IEEE 802.3cg
Clause 148 cleanup
September 9th, 2019

- During the initial SA ballot phase there have been a number of comments asking for clarifications and fixing state diagram semantic. These were mainly related to:
 - Timers and tolerances
 - Clocks & timings definition
 - Execution order of state diagram statements
 - Operators precedence
- None of these comments was intended to change the functionality being described
 - But they introduced a few editorial and technical regressions
- Several individuals with different affiliations worked in background to stabilize the draft
- This presentation shows the final changes that have been checked and validated by all parties

Figure 148-4—PLCA Data state diagram

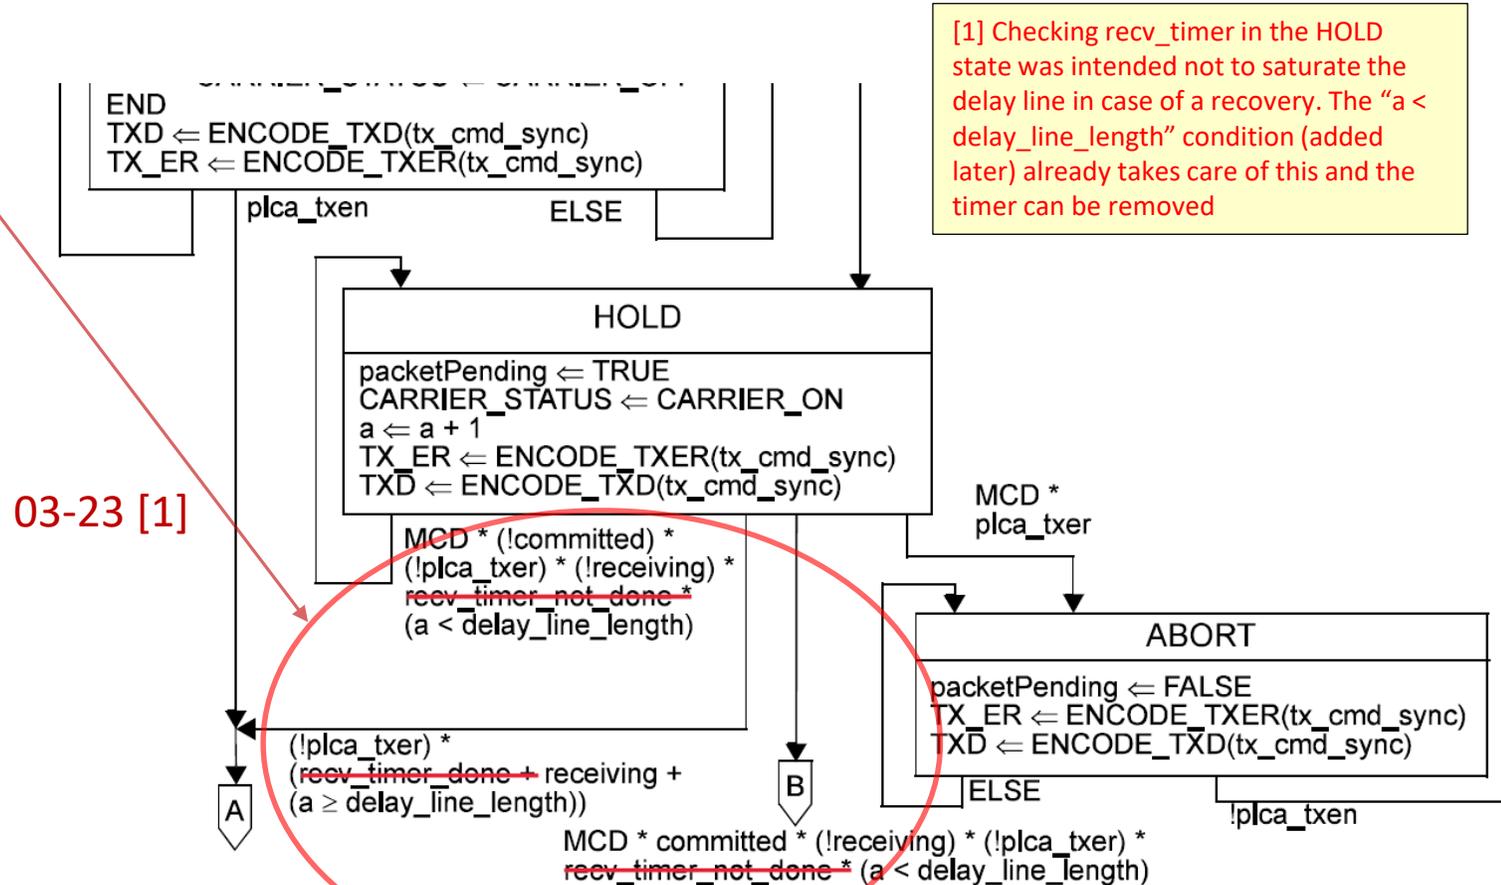
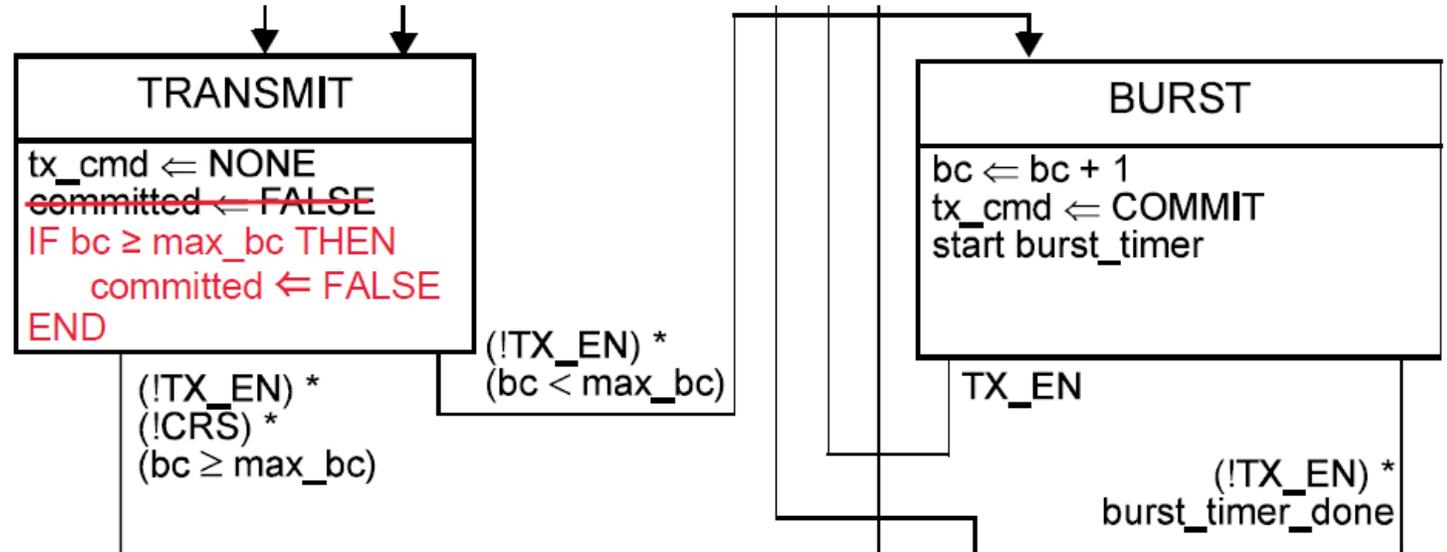
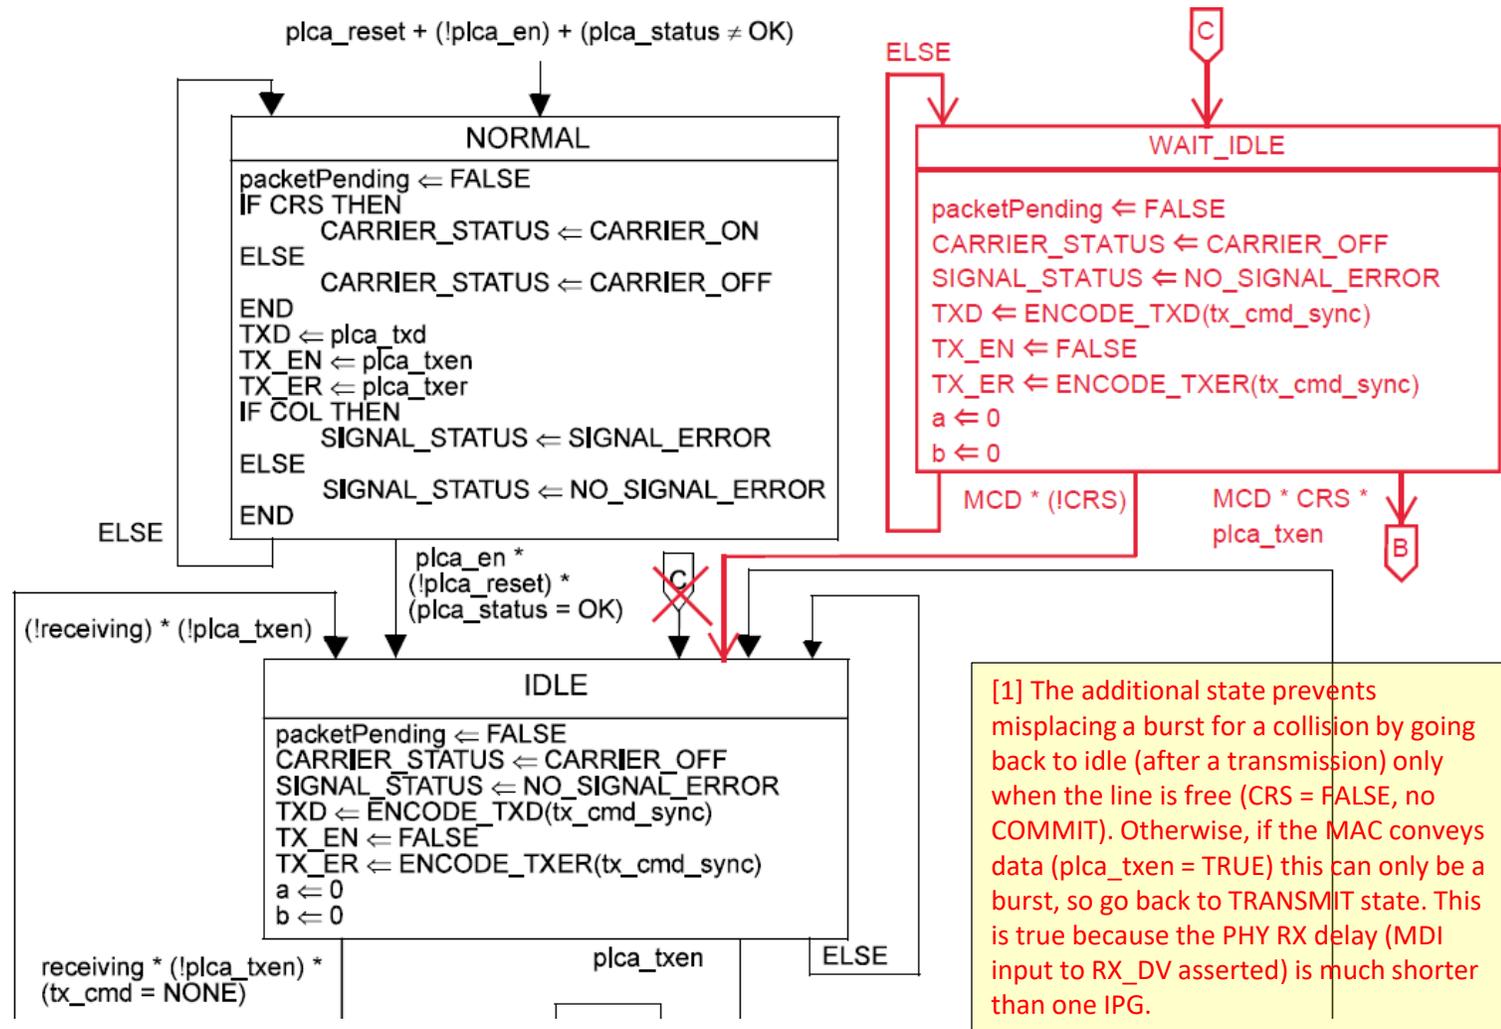
[5] setting the "committed" variable to FALSE, unconditionally, may prevent the PLCA Data State Diagram from bursting.

[1] According to Clause 147 PCS Receive State Diagram the COMMIT request is looped back into a COMMIT indication via MII. If the implementation does not handle this correctly, the burst mode may not work (always trigger a collision). An additional state is required to clarify the behavior of the state diagram when bursting.

[5] just keep the committed variable set during a burst, so that the DATA Stat Diagram will always be able to send
